PROJECT MEMORANDUM

Project: Darfield Agrivoltaic Development

Memo: 1/R2

Topic: Request for Additional Information (S92) Response

Figure 1: Proposed Mitigation (as per the Landscape Assessment Report)

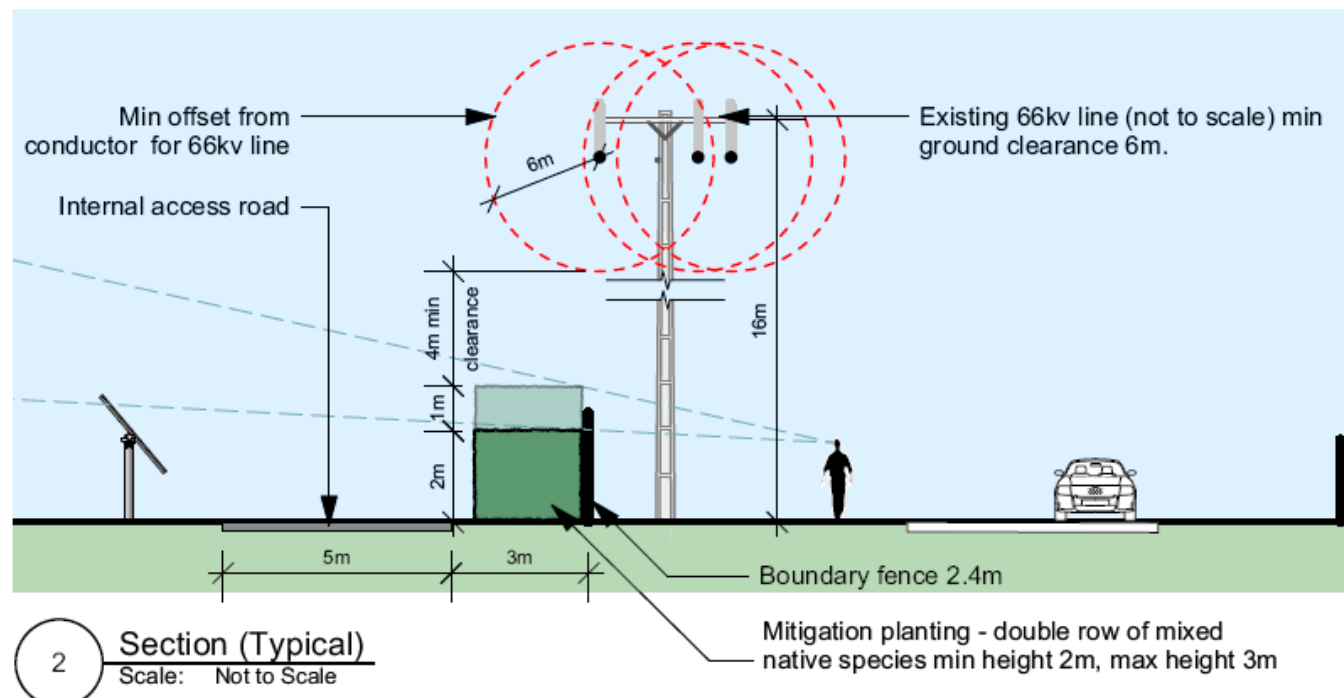
The mitigation approach identified in the landscape and visual assessment report differs from that required in the proposed condition. It is unknown if that report was made available to Mr Van der Velden. The landscape and visual assessment report recommended the use of screen planting as per the following figure:

At the time of assessment, the approach proposed by the applicant was to use screen planting to mitigate the landscape and visual effects of the solar farm. The planting would be retained at a height of between 2m and 3m (to minimize shading of the PV panels). To partially mitigate the effects of glint and glare on surrounding properties and the road and rail network, a combination of screen planting and PV tracking management was proposed.

The above condition does not align with the recommendations contained in the landscape and visual assessment report, which recommended the use of screen planting and tracking management instead of shade cloth. The use of shade cloth was not originally proposed because of the potential for the winds in the area to damage it (potentially affecting visual amenity).

In response to point 1 of the peer reviewer's comments (above), the intended approach to the mitigation of glint and glare was a combination of physical screening (maintained at a height of between 2 & 3m), installation of the PV arrays at the minimum height and PV tracking management.

It is now proposed that yellow glare will be mitigated by screening and ensuring that the PV Arrays in the locations expected to produce yellow glare are installed at minimum height. Any effects of green glare that are identified as a traffic safety issue by Mr McKenzie (Traffic expert) will be addressed through tracking management (if necessary) This approach will further reduce the risk of glint and glare becoming a traffic safety issue.

Figure 2: Temporary mitigation requirements (dark blue line)

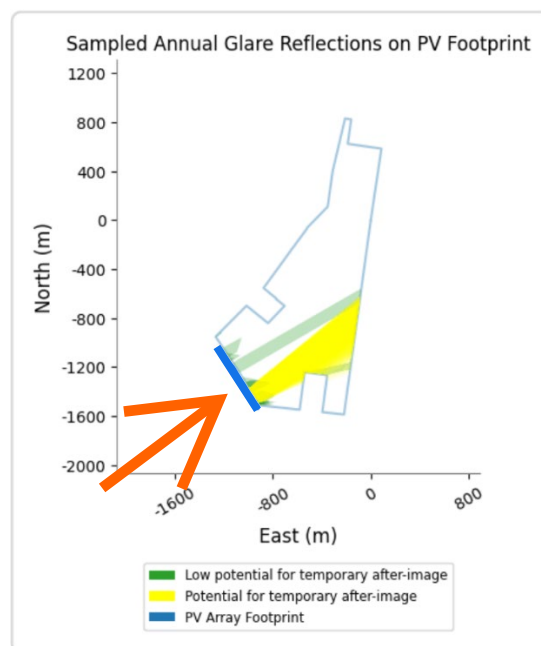
In response to point 3, mitigation can be achieved instantly through the establishment of a shade cloth fence to 3m until the mitigation planting becomes established and reaches a height of 3m. This will provide a margin of safety.

In response to the change identified above and the concerns outlined by Mr Van der Velden's review, it is recommended that the proposed screen planting be established and maintained at a minimum height of 3m and that the PV arrays (in the locations likely to produce glare) are installed at the minimum installation height. Until the mitigation planting reaches a height of at least 3m and canopy closure occurs or post-implementation monitoring shows that glare is not an issue, a 3m high section of shade cloth fence should be erected along the boundary of the site and SH73.

The extent of the temporary mitigation required (to 3.0m) is shown as a dark blue line in the following figure, which also shows that part of the solar farm expected to produce the glare.

Darfield Preliminary and Route: Homebush Road West of Railway No Mitigation

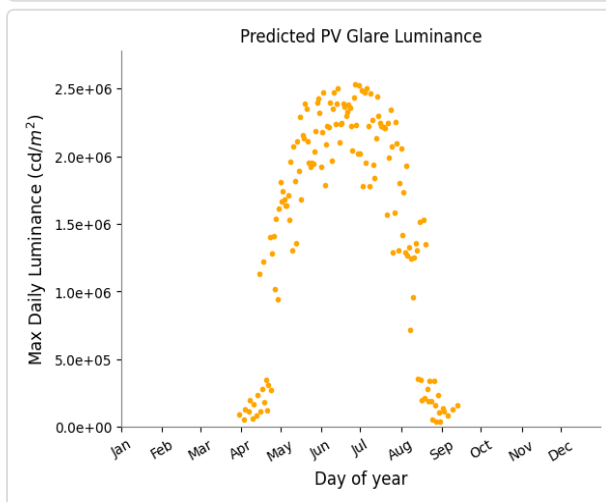
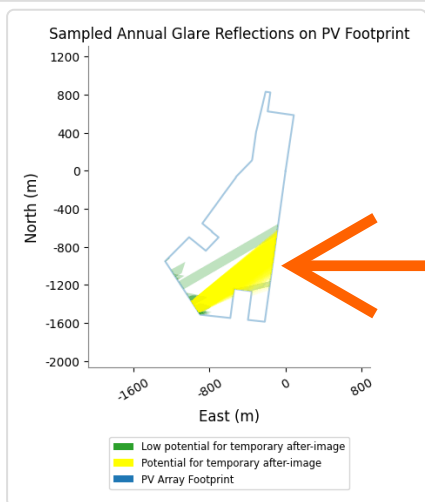
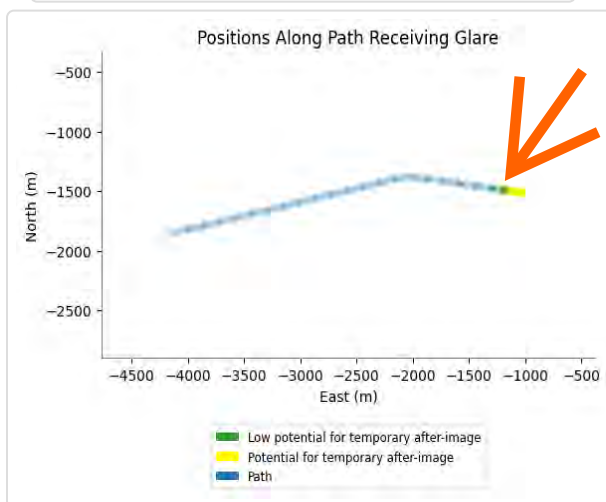
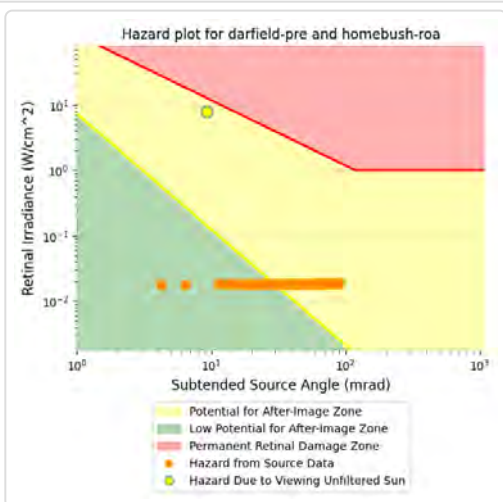
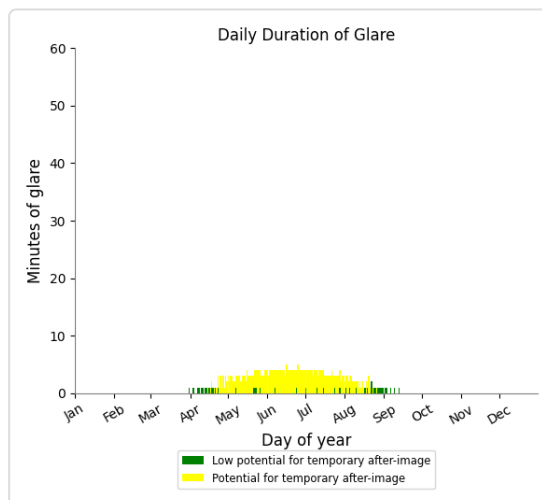
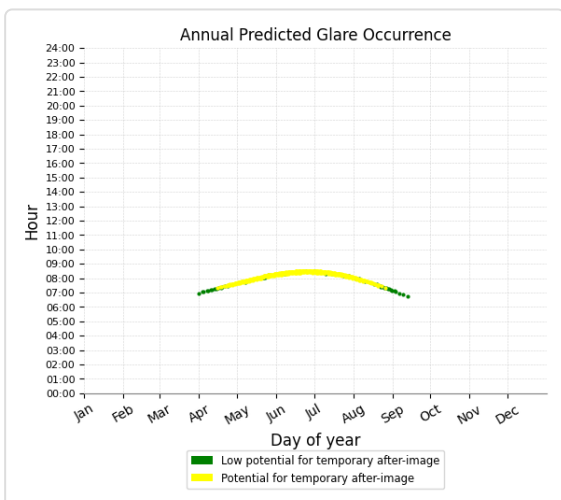
At the intersection of SH73 and Homebush Road, a minimum height of 3m is required (as identified above) to mitigate the effects of yellow glare in the intersection. Green glare is still expected to occur for up to five minutes per day between 7am and 9am from April until October.

Further analysis, using the NZTA driver height for trucks, showing the effectiveness of 3m high mitigation on glare on SH73 and its intersection with Homebush Road is appended to this response. This shows yellow glare (refer to the indicator arrows on the attached pages) is mitigated and that only a short period of green glare is expected to be experienced in the morning when the proposed PV Arrays are installed at minimum height. The extent to which any amendments to the mitigation will affect traffic safety and if the green glare is an issue will be responded to separately by Mr McKenzie (Traffic Safety Expert). Should Mr McKenzie recommend that the green glare requires mitigation, then this will be undertaken through tracking management techniques.

Yellow glare: 370 min.

Green glare: 45 min.

Darfield Preliminary and Route: Homebush Road West of Railway 3m High Mitigation

Yellow glare: none

Green glare: 415 min.
